ORDINANCE 99-06

TO AMEND THE PRELIMINARY PLAN FOR THE BELLE TRACE PLANNED UNIT DEVELOPMENT
Re: 3630 East 10th Street
(CarDon & Associates, Petitioner)

CASE NO: PUD-77-98
DATE: February 1, 1999

1999 SITE PLAN

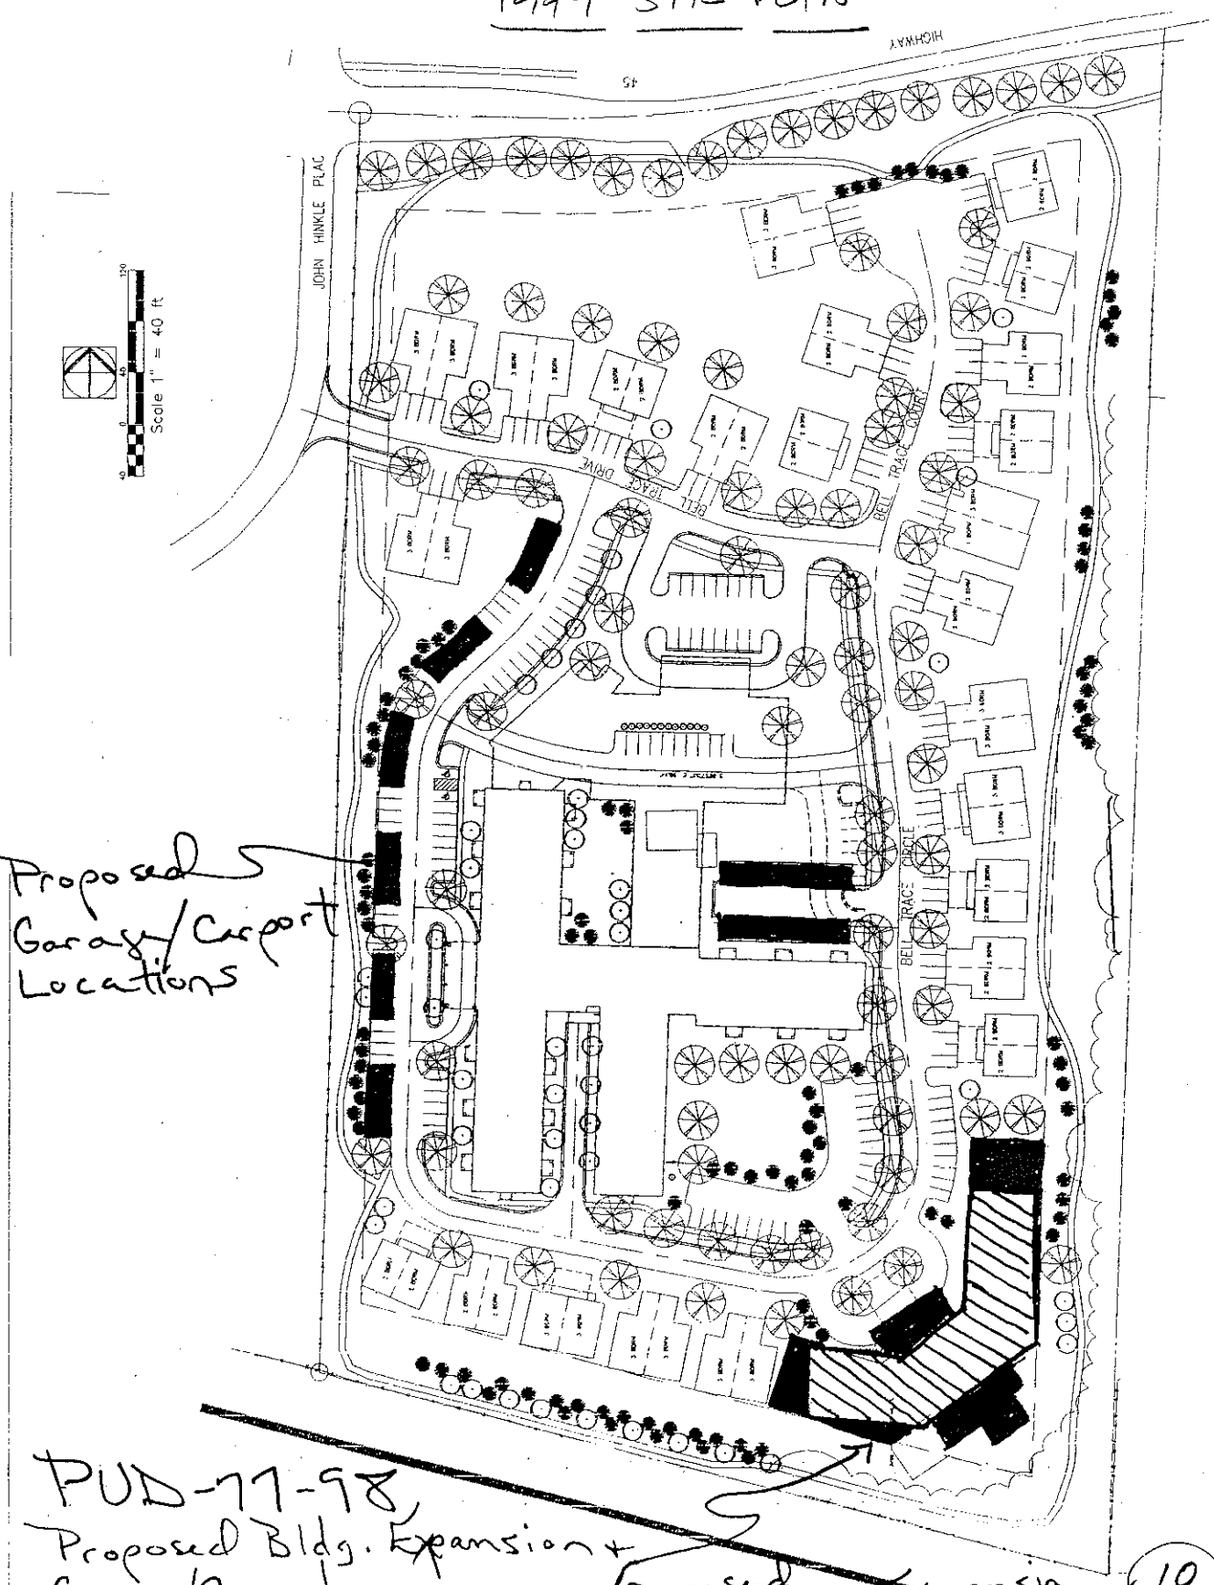
REPORT SUMMARY: The first request is for the enlargement of the nursing home facility. PUD regulations require a major plan amendment when the cube of building increases more than 20%. The petitioner was granted approval to place the nursing home facility in the southeast corner of the site in the 1997 approval. The facility was approved as a 16,800 square foot, one story building. The requested expansion of the proposed single story building to 22,000 square feet is a 24% increase in the cube of the building. Since the initial hearing the proposed location of the building has been moved out of the 60 foot required setback, and will not require the removal of additional trees. The expansion is needed to allow more single bed private rooms for the patients. Staff is supportive of this building enlargement for better patient care.

The second petition request is for the creation of 58 covered parking spaces. These parking spaces currently exist on the site. Many of the residents will have cars. To assist these people in keeping their cars free of ice and snow, the petitioner is requesting carports and garages for some of the parking spaces. This request does not impact open space, and tree preservation is not an issue. The carports and garages are proposed to be brick with shingled roofs. Staff is supportive of the use of carports and garages.

1) A tree buffer shall be placed along the east edge of the property in the area of the detention facility. A minimum of seven (two inch caliper) hardwood deciduous trees and five (6 foot tall) evergreen trees will be installed in the 1999 planting season.

PUD-77-98
Landscape Plan

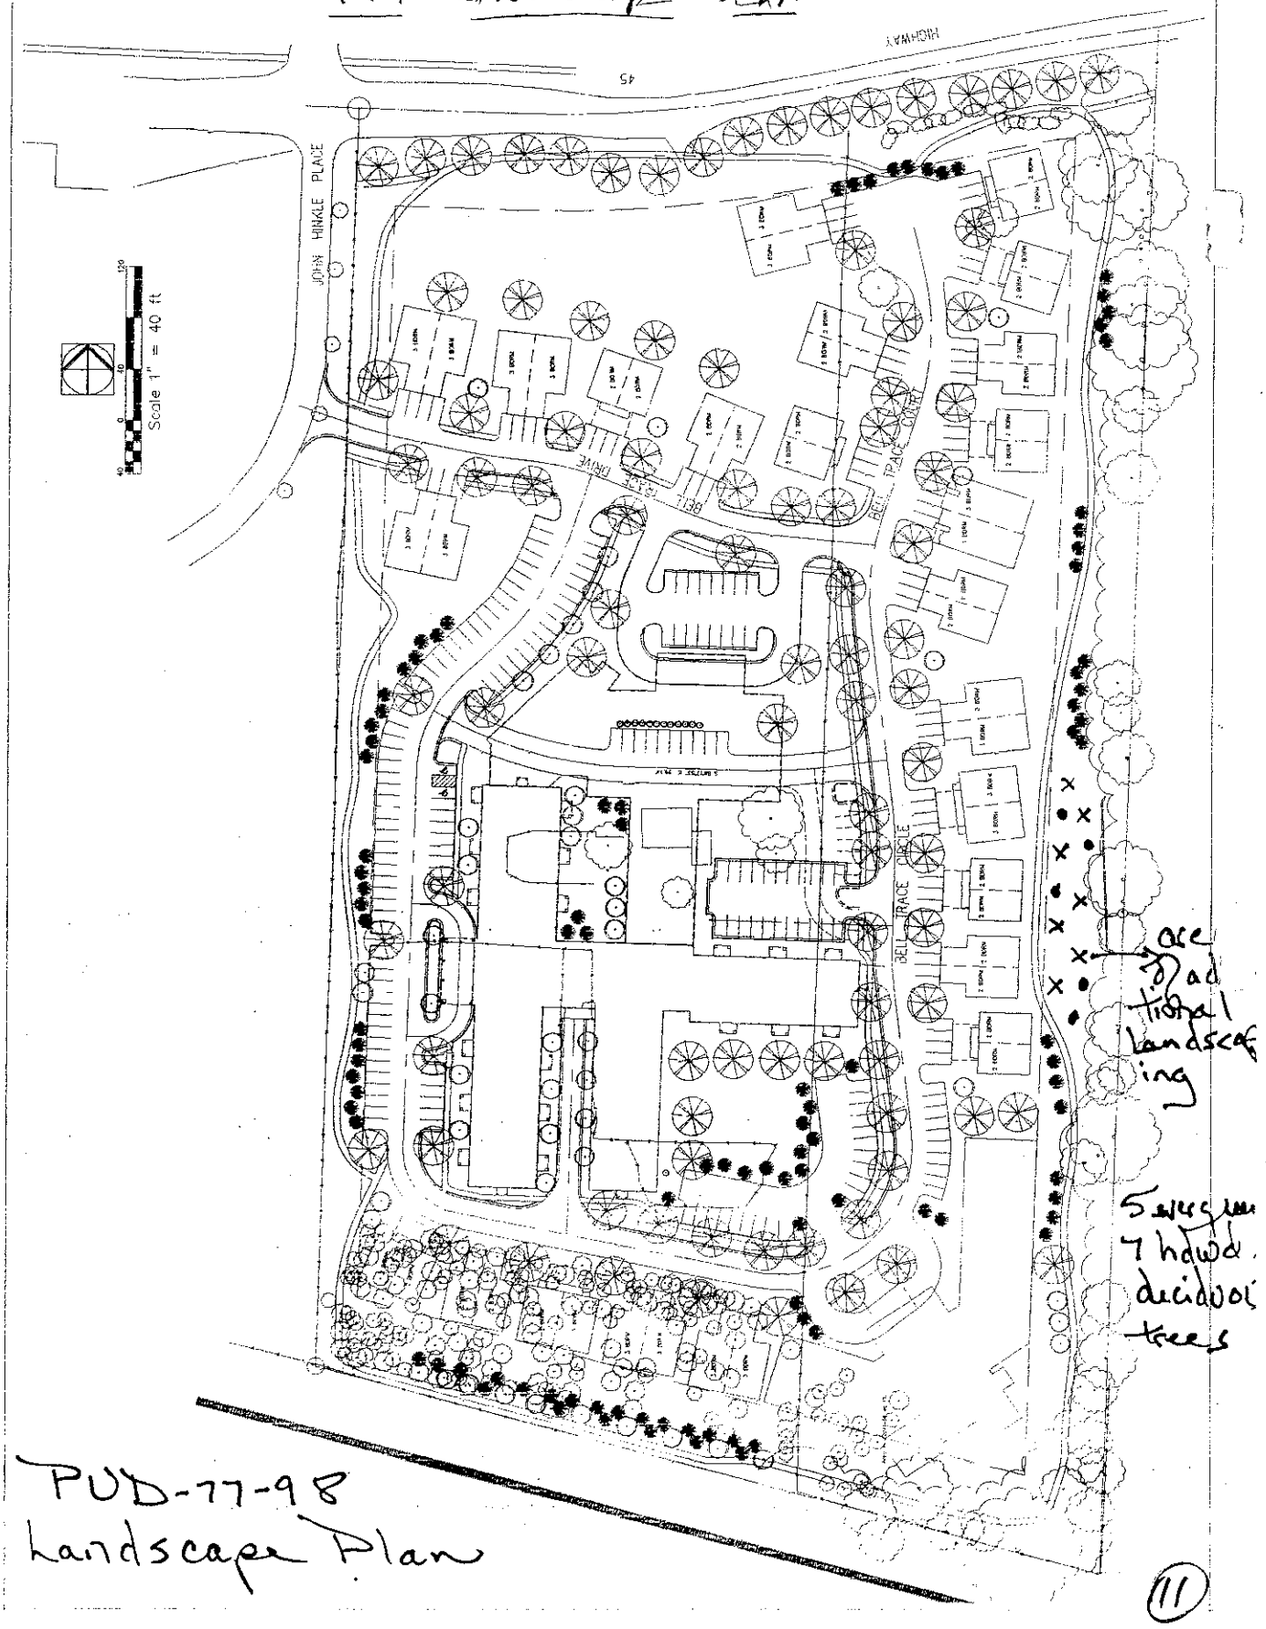
During the course of the neighborhood meeting and the preliminary Plan Commission hearing on January 11, 1999, two concerns were brought forth. The first is the lack of tree buffer in the vicinity of the eastern detention area. The

petitioner has agreed to place a minimum of seven hardwood deciduous trees and five evergreen trees in this area. Then once the cottages are constructed in that area, additional landscaping will be placed. The second concern was the exterior lighting plan for the complex. Instead of placing brighter security lighting on the main building, the petitioner has agreed to place pedestrian scale lighting on the interior streets of the development.

Proposed covered parking shelters for
BELL TRACE RETIREMENT COMMUNITY
3630 East Tenth Street
Bloomington Indiana

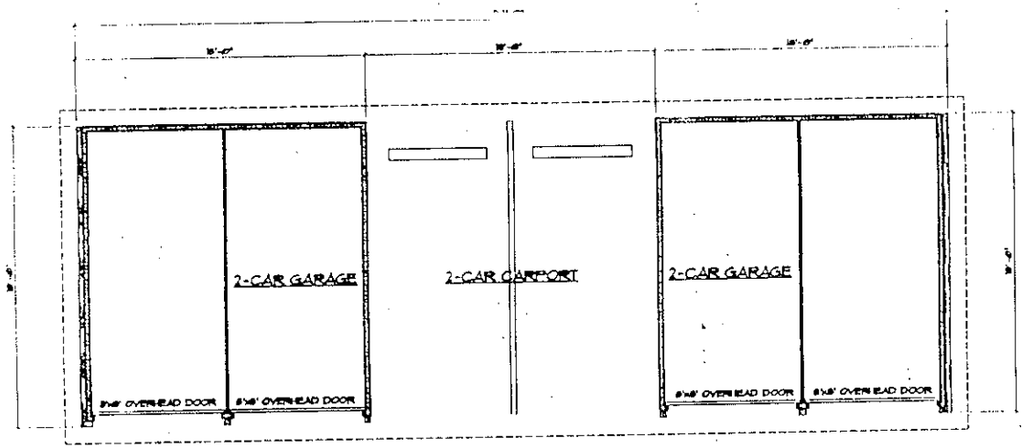
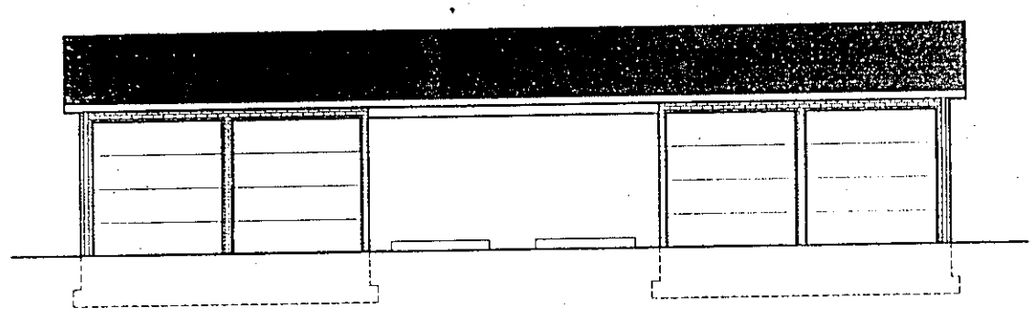
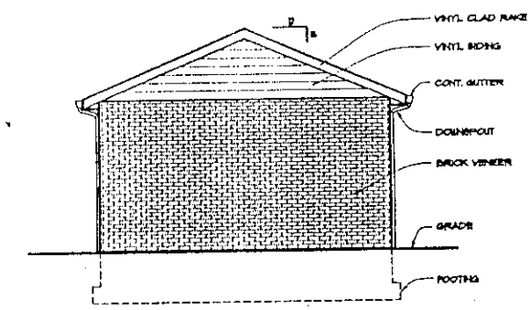
The third petition request is for the creation of 58 covered parking spaces. These parking spaces currently exist on the site. Many of the residents will have cars. To assist these people in keeping their cars free of ice and snow, the petitioner is requesting carports and garages for some of the parking spaces. This request does not impact open space, and tree preservation is not an issue. The carports and garages are proposed to be brick with shingled roofs. Staff is supportive of the use of carports and garages.
